# Template for comments and secretariat observations

Date: 2014-10-22	Document:	Project: EN 1993-1-8
------------------	-----------	----------------------

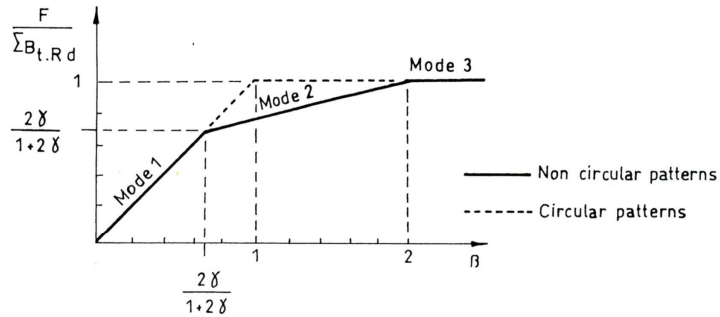
$$L_b \leq \frac{8,8m^3 A_s}{\sum \ell_{eff,1} t_f^3}$$

is for column bases!! and not for beam-to-column connections !

For b-t-c connections should be:

Prying forces are active in Mode 1 and 2, what means when  $\beta < 2$

## Background 2 for rev EN 1993-1-8/6.2.7.2 (9)

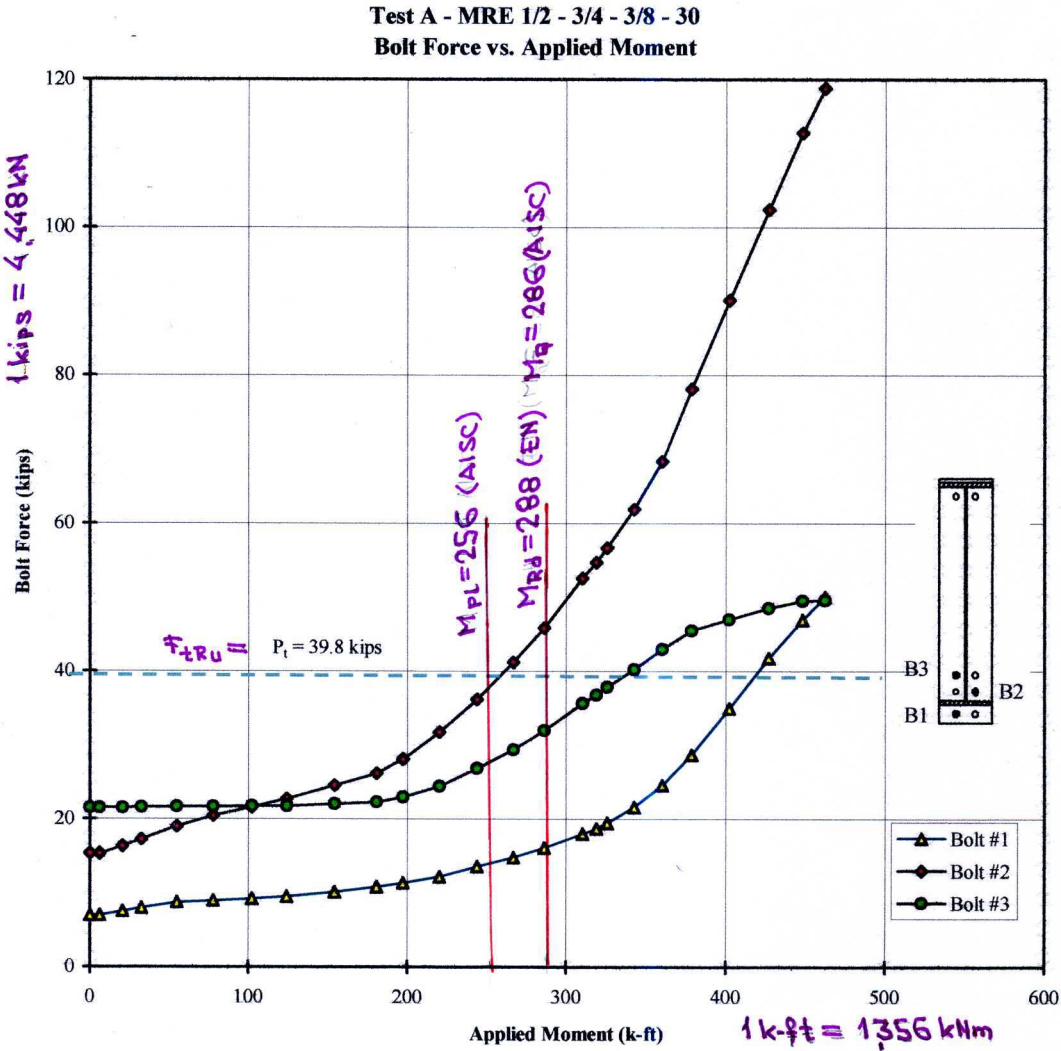
Following experimental test results show that real forces in bolt rows can exceed design resistance of the bolt, what can be dangerous.

Fig.2.1. Schema and MES model of investigated beam splice (it is partial strength bolted connection of beam loaded in elastic range)

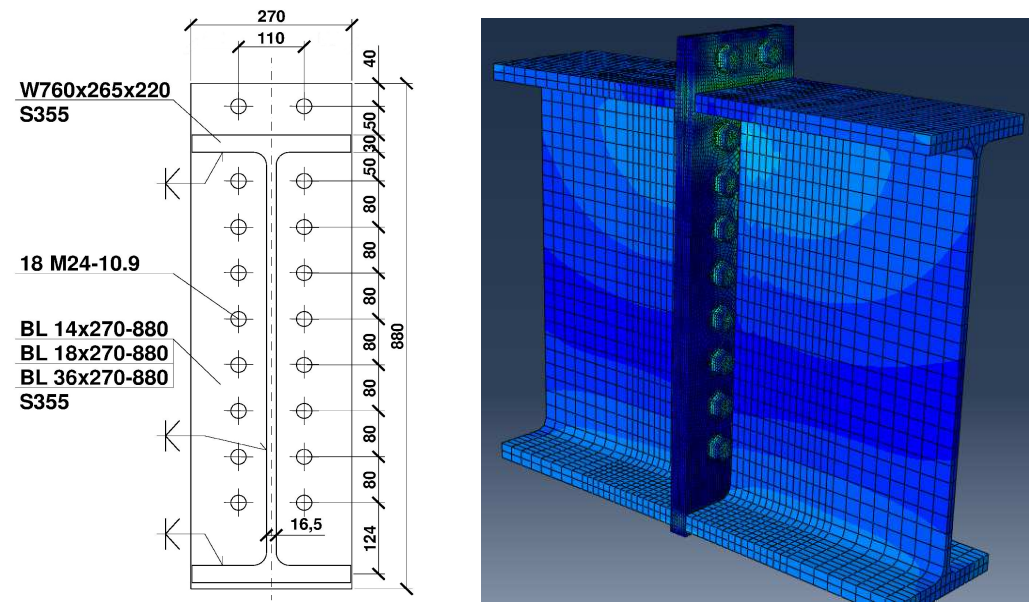
Investigated extended end-plate splice of W760x265x220 beam have end-plate thickness  $t_p=14; 18; 24$  and  $36\text{mm}$  and one row extended and 8 or 3 internal bolt rows between beam flanges. Steel S355 and bolts M24-10.9 class are assumed. Design and ultimate moment resistances of the splice are calculated according to EN 1993-1-8/6.2.7.2(9). The same limit states of design moment resistance and ultimate moment (for plastic end-plate resistance or ultimate bolt resistance) are analyzed in 9 FEA models not prestressed connections in ABAQUS program. As the results bolt forces distribution in all rows at the design moment resistances of the connections are presented.
